## Design Team Point of View

*Item 3, 11/15/23 CHB HARRIS*  
 EXH. A: EXCERPTS CHB STAFF REPORT (12/17/1980)

RE: Nomination of the Eastside Social Services Center (the former University Heights Junior High School) to CHB Landmark Status.

EXH. G: COLOR SUGGESTIONS (DESIGN CONCEPT, PRESENTATION, PP. 7-8)

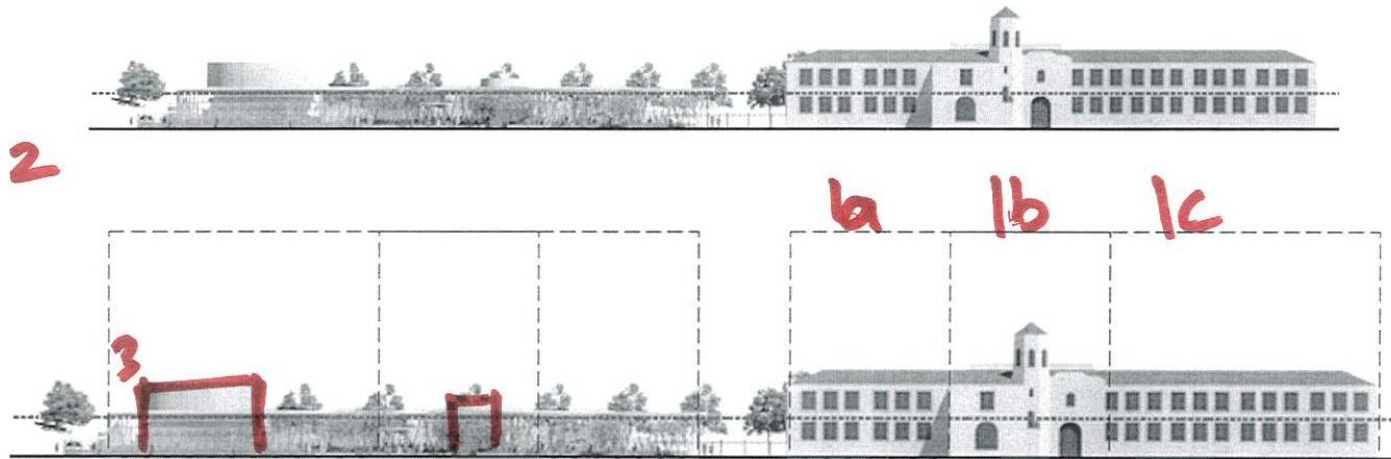
- (1) white body (as currently proposed) should echo color of existing landmark. Also consider maintenance.
- (2) red trim should echo existing landmark (e.g., roof tile, trim), such as the project's (a) signage, (b) roof projections, (c) louvered canopy
- (3) Off-white accent should echo color of existing landmark (e.g., punctuated entrance/vents), such as the projects (a) entrance and (b) signage background

1. Discussed in Exhibit B.
2. Discussed in Exhibit B.
3. Discussed in Exhibit B.

The exterior solar screen is designed to reflect a pattern found in the structure of the Library building. The elegant and refined pattern will become a character defining element of the Library building for years to come.

EXH. H: COMPONENT ORIENTATION (PRESENTATION, P. 6)

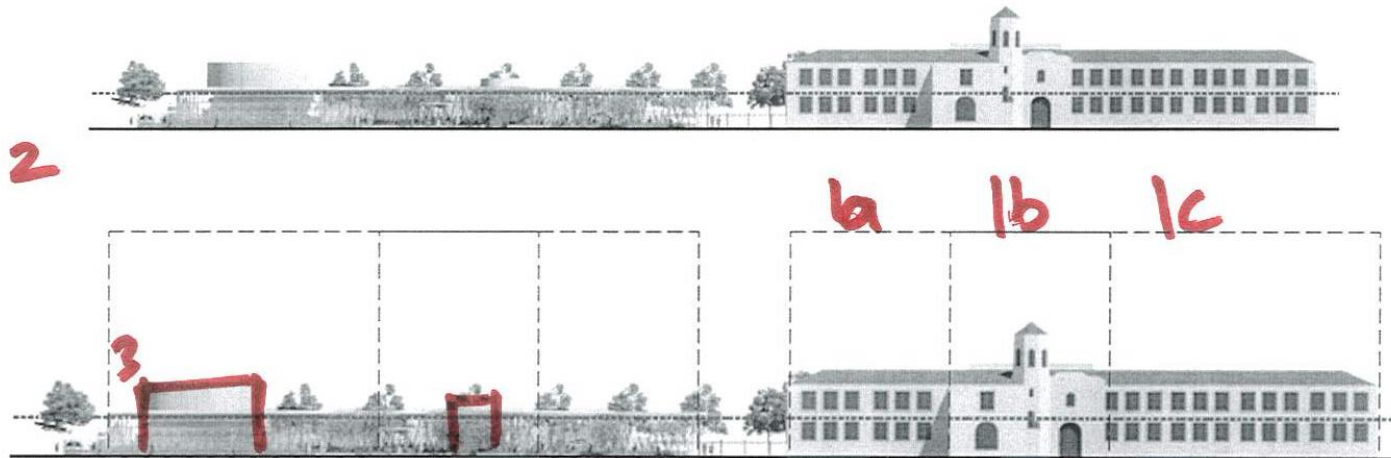
- (1) Landmark 3 main components (a) east pavilion (b) entrance (c) west pavilion (see also Exh. I below)
- (2) Projects overall length matches but components need better definition (e.g., perhaps roof element/projections)
- (3) If feasible, move entrance component west to mirror existing landmark with revised roof projections (e.g., reorienting circular rooms seems feasible). This would improve pedestrian orientation and focus main entrance to facilities to entire facilities and both structures).
- (4) Scale, arrangement, maybe contingent on orientation perspective (e.g., appx 100 feet from university sidewalk cf. central entrance).

1. The Library building has a single open floor plate where the flow of people is encouraged without encumbrance. The floor plate is supported by 3 elliptical cores that can be interpreted as related to the three parts of the Cesar Chavez Community Center identified.
2. The overall length of the Library is derived from the size of the program required. The project is meeting the budget requirements by only introducing elements required for the function of the Library. Modern design sensibilities discourage the use of additive elements that are not functionally required.

EXH. H: COMPONENT ORIENTATION (PRESENTATION, P. 6)

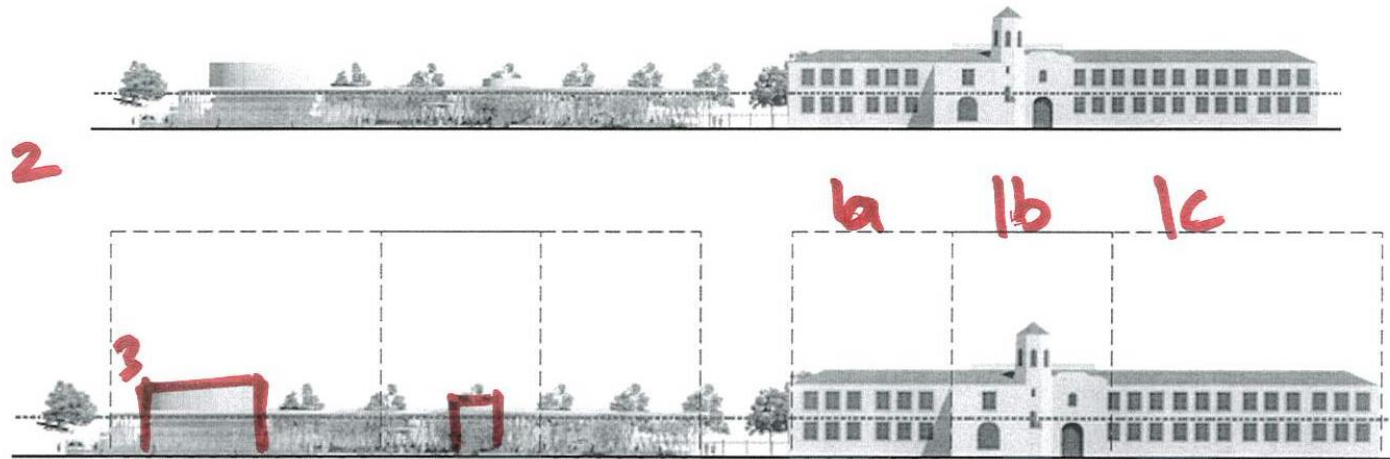
- (1) Landmark 3 main components (a) east pavilion (b) entrance (c) west pavilion (see also Exh. I below)
- (2) Projects overall length matches but components need better definition (e.g., perhaps roof element/projections)
- (3) If feasible, move entrance component west to mirror existing landmark with revised roof projections (e.g., reorienting circular rooms seems feasible). This would improve pedestrian orientation and focus main entrance to facilities to entire facilities and both structures).
- (4) Scale, arrangement, maybe contingent on orientation perspective (e.g., appx 100 feet from university sidewalk cf. central entrance).

- 3. The entry portal frame has been shifted one bay to the left of the image to strengthen the relationship to the information desk on the interior. The expression of the entry portal frame in addition to the massing and crescent form of the building contributes greatly to the orientation of pedestrians to the front door by creating a welcome plaza on the concave side of the building with the entry door as the keystone of the arch in plan.

EXH. H: COMPONENT ORIENTATION (PRESENTATION, P. 6)

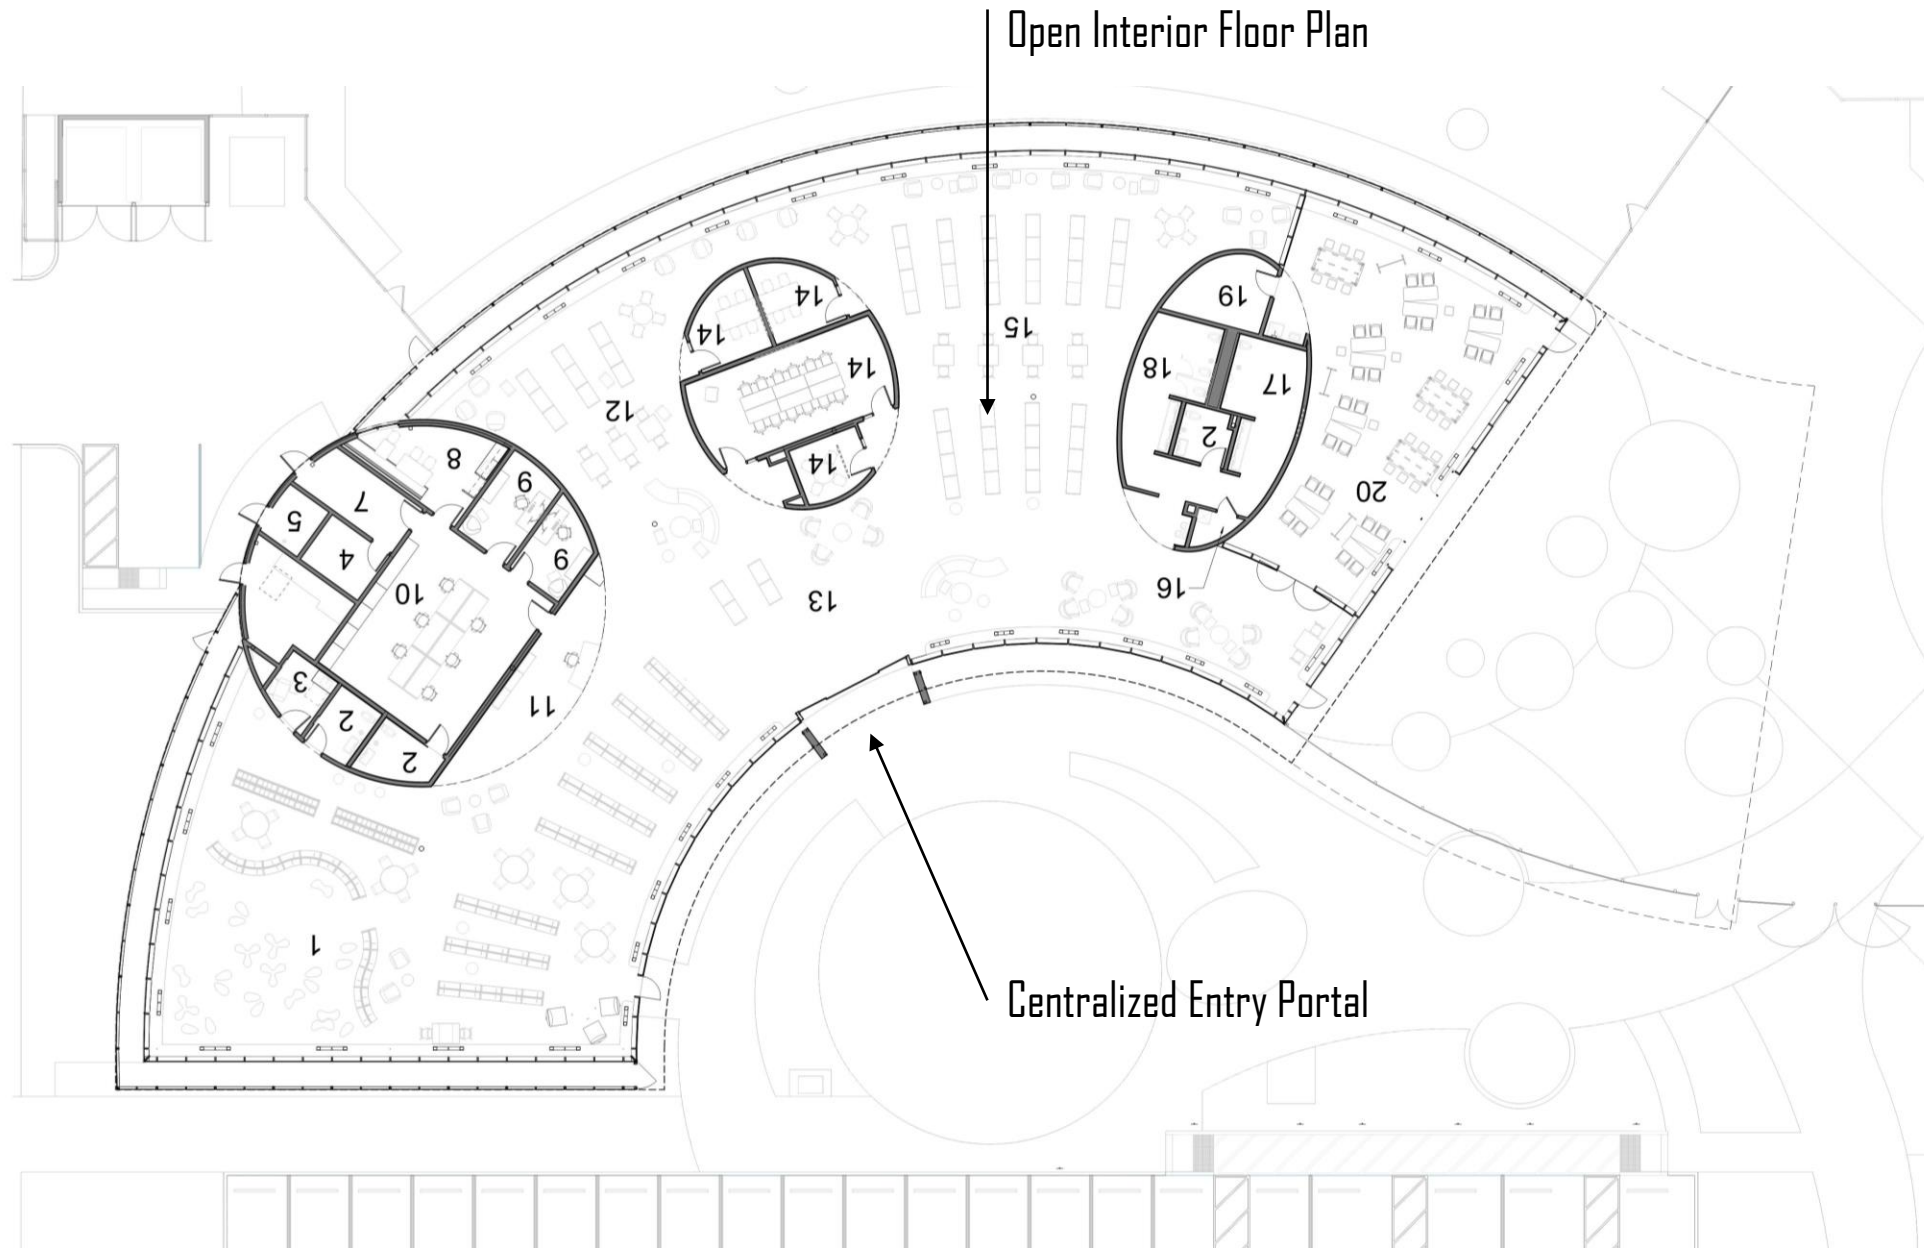
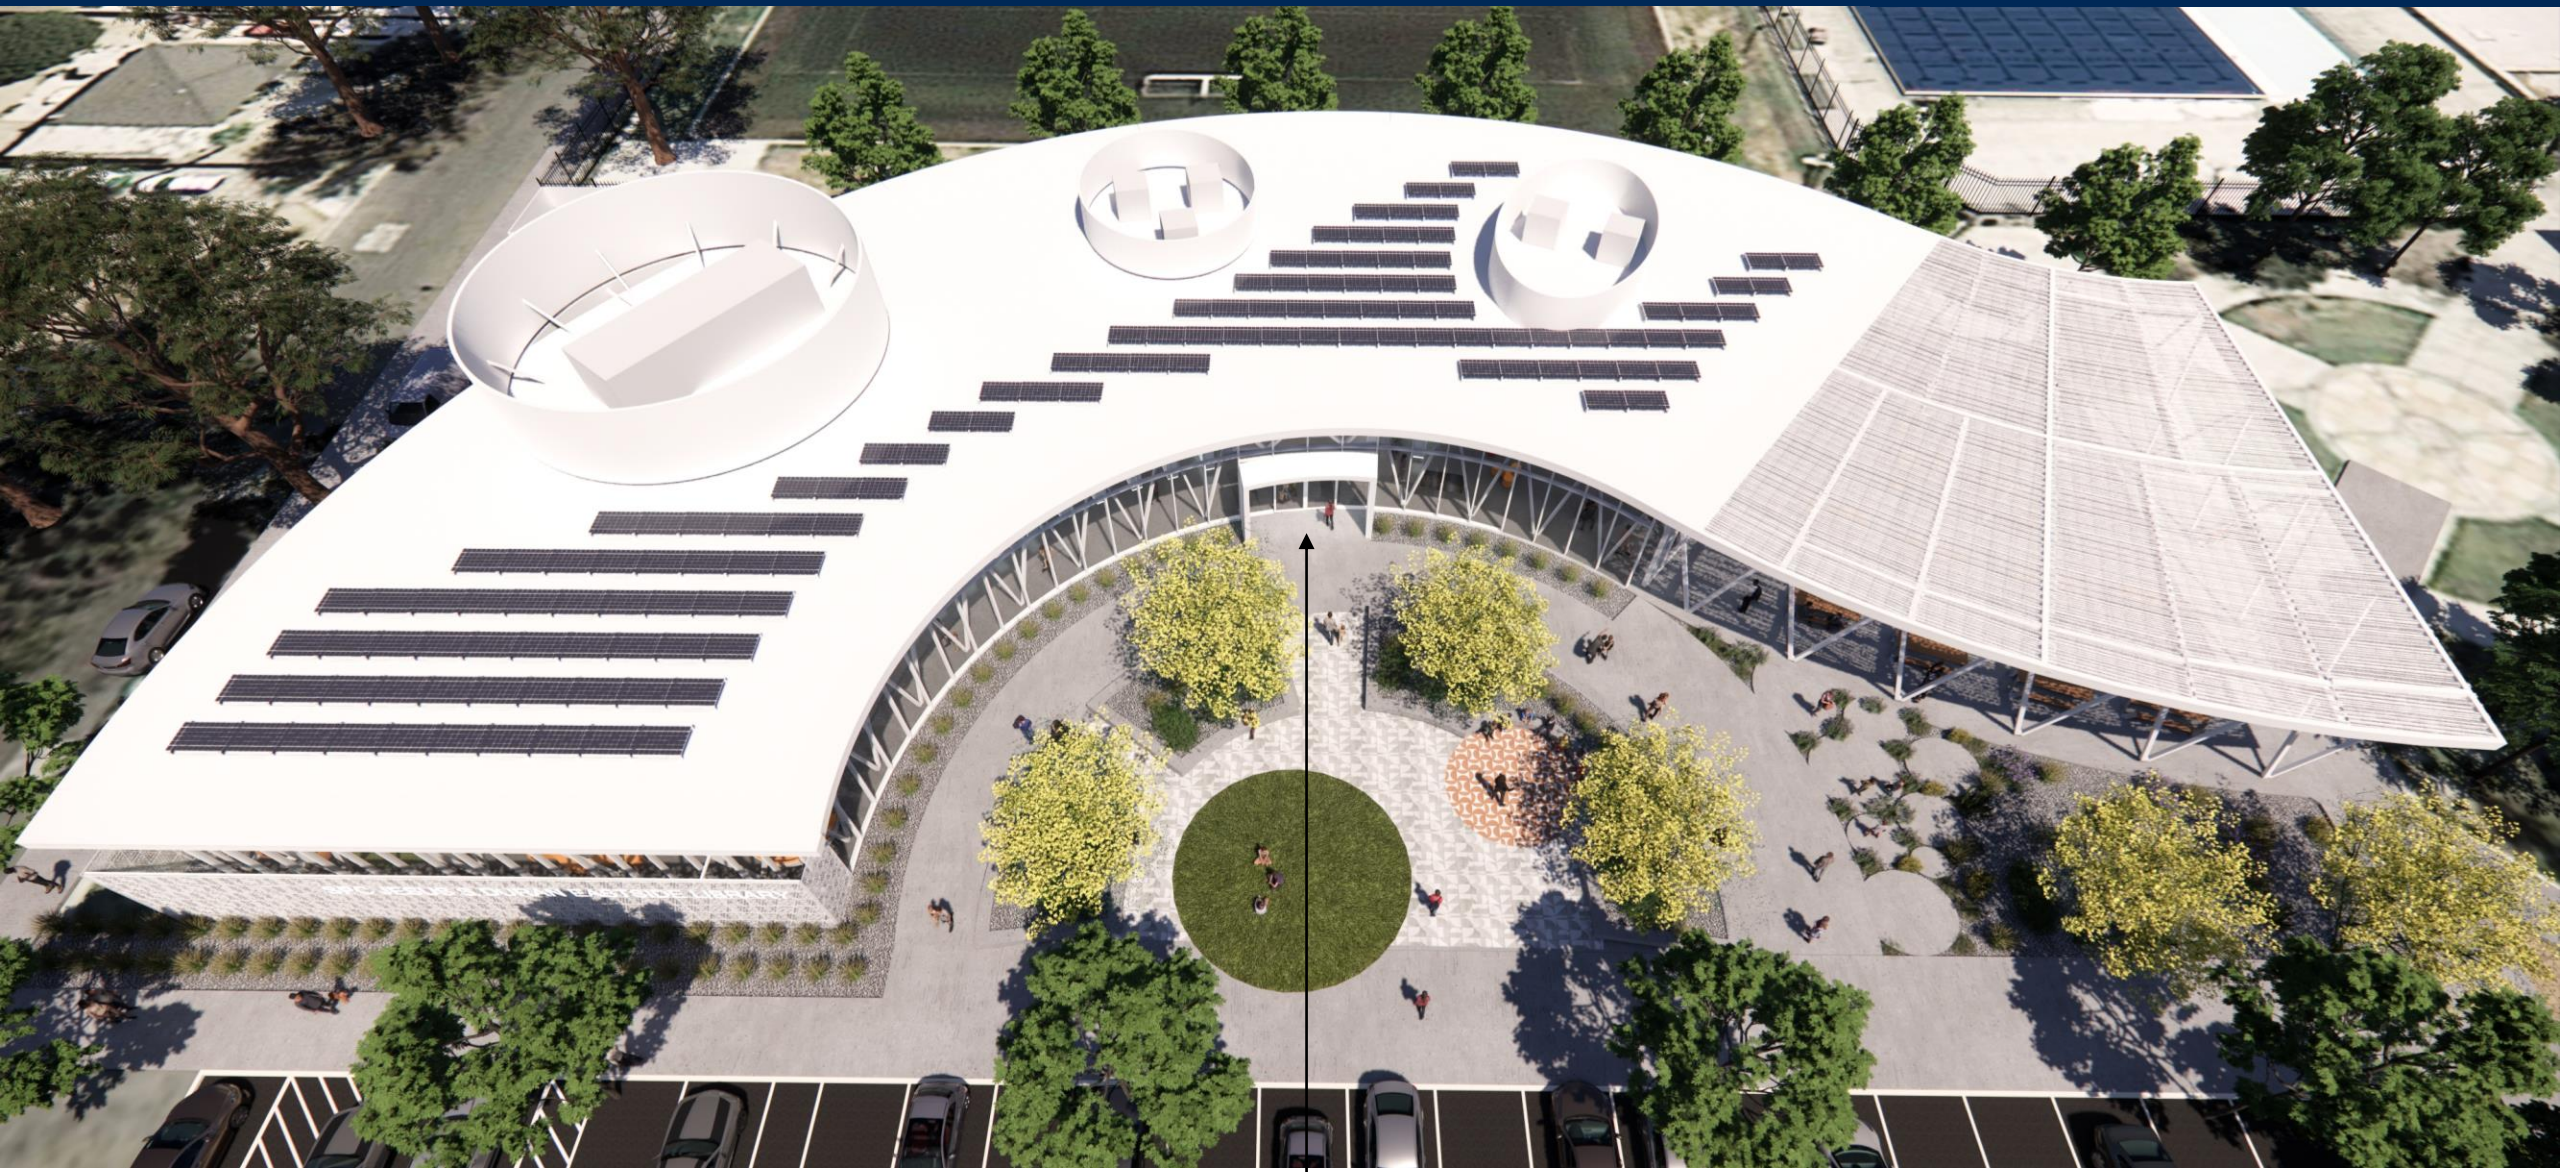
- (1) Landmark 3 main components (a) east pavilion (b) entrance (c) west pavilion (see also Exh. I below)
- (2) Projects overall length matches but components need better definition (e.g., perhaps roof element/projections)
- (3) If feasible, move entrance component west to mirror existing landmark with revised roof projections (e.g., reorienting circular rooms seems feasible). This would improve pedestrian orientation and focus main entrance to facilities to entire facilities and both structures).
- (4) Scale, arrangement, maybe contingent on orientation perspective (e.g., appx 100 feet from university sidewalk cf. central entrance).

4. The relationship and regulating lines between the two buildings is very difficult to experience.

The plan relationship of the two buildings will create a very different experience than the straight on comparison view of the exhibit. The Library has been designed to meet the needs of it's program and budget. There is a general alignment of the roof line to the mid point of the Community Center building and we are unable to lower the roof due to minimum clearance requirements or raise the roof due to increased cost of exterior envelope.

EXH. I: ORIENTATION & REGULATING LINES (DESIGN CONCEPT, PRESENTATION, PP. 6, 8)

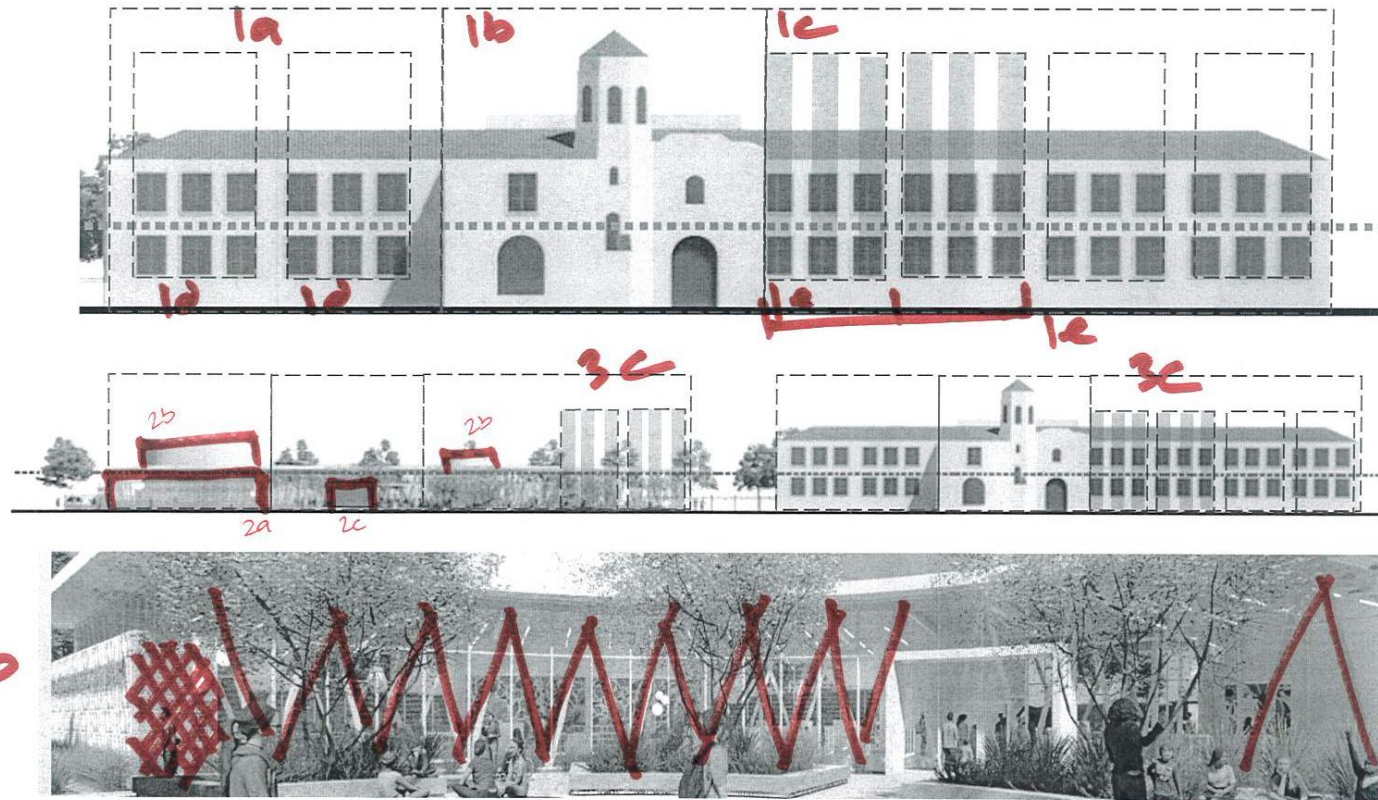
- (1) Landmark 3 main components (a) east pavilion (b) entrance (c) west pavilion with (d) consistent bays and (e) window columns
- (2) Alternatively (if not mirrored but rather matched components [as currently proposed]), suggest modifying (a) eastern frontage and (b) roof projections to better define entrance component, and (c) move main entrance to centrally locating within entrance component.
- (3) For exterior skin suggest (a) incorporating scale of bays and windows and (b) remove V-shaped support structure (seems busy, distracting, unnecessary cost, introduces seemingly new element); and (c) glazing should not distract or introduce new colors.

1. The assessed three-part relationship of the Cesar Chavez Community Center building relates to the historic internal planning of the building, to provide access to light and natural ventilation and is not transferrable to the Library where the form is derived from a different function. The central element of the Community Center is also a characteristic of the Mission Style architecture of the time and does not exist in the modernist pavilion architecture.

EXH. I: ORIENTATION & REGULATING LINES (DESIGN CONCEPT, PRESENTATION, PP. 6, 8)

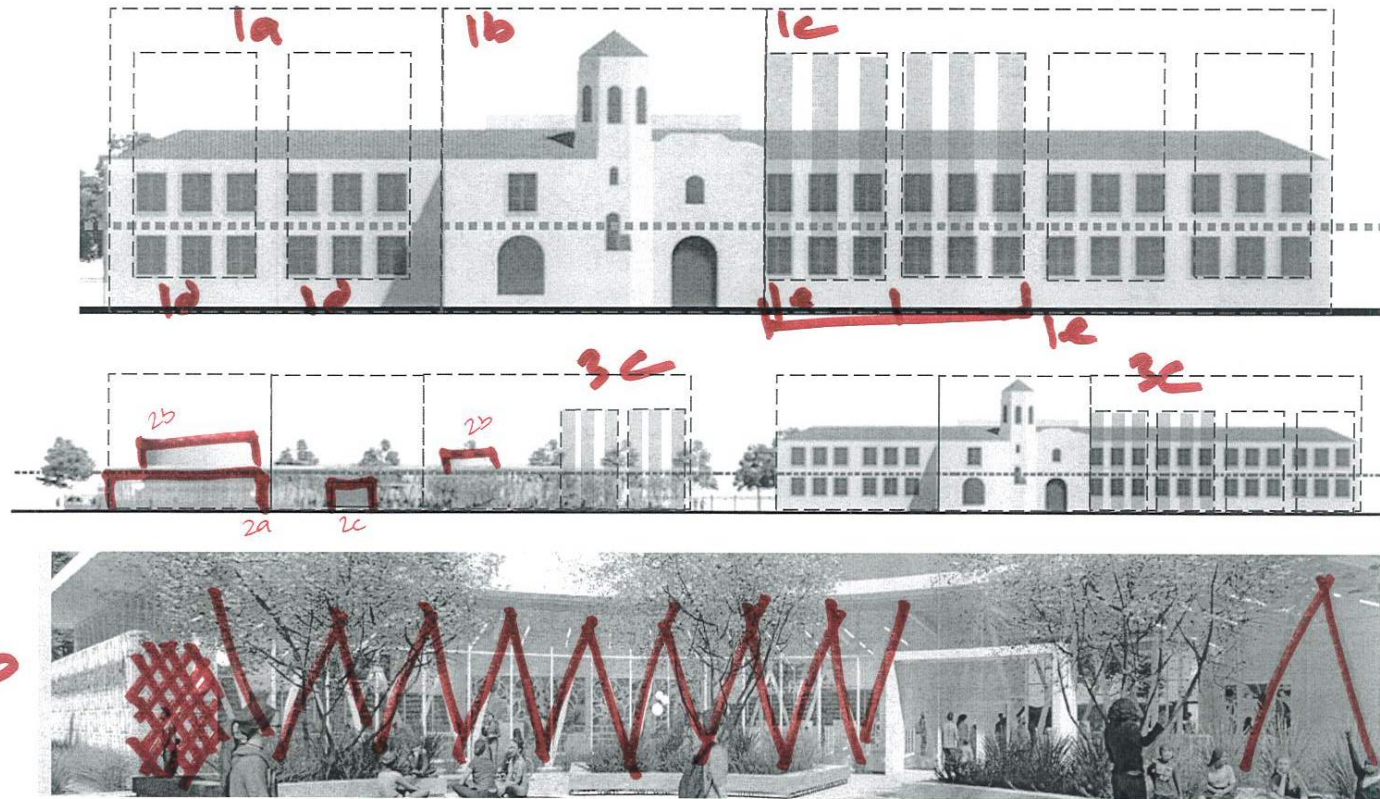
- (1) Landmark 3 main components (a) east pavilion (b) entrance (c) west pavilion with (d) consistent bays and (e) window columns
- (2) Alternatively (if not mirrored but rather matched components [as currently proposed]), suggest modifying (a) eastern frontage and (b) roof projections to better define entrance component, and (c) move main entrance to centrally locating within entrance component.
- (3) For exterior skin suggest (a) incorporating scale of bays and windows and (b) remove V-shaped support structure (seems busy, distracting, unnecessary cost, introduces seemingly new element); and (c) glazing should not distract or introduce new colors.

2. The exterior expression of the Library is derived by a direct response to the internal planning of the building to create a holistic and integrated architectural expression that is honest about its interior function.

The entry frame is a 4' deep projection beyond the exterior envelope of the building to indicate the building entrance and is currently located in the center of the building with equal structural bays on either side.
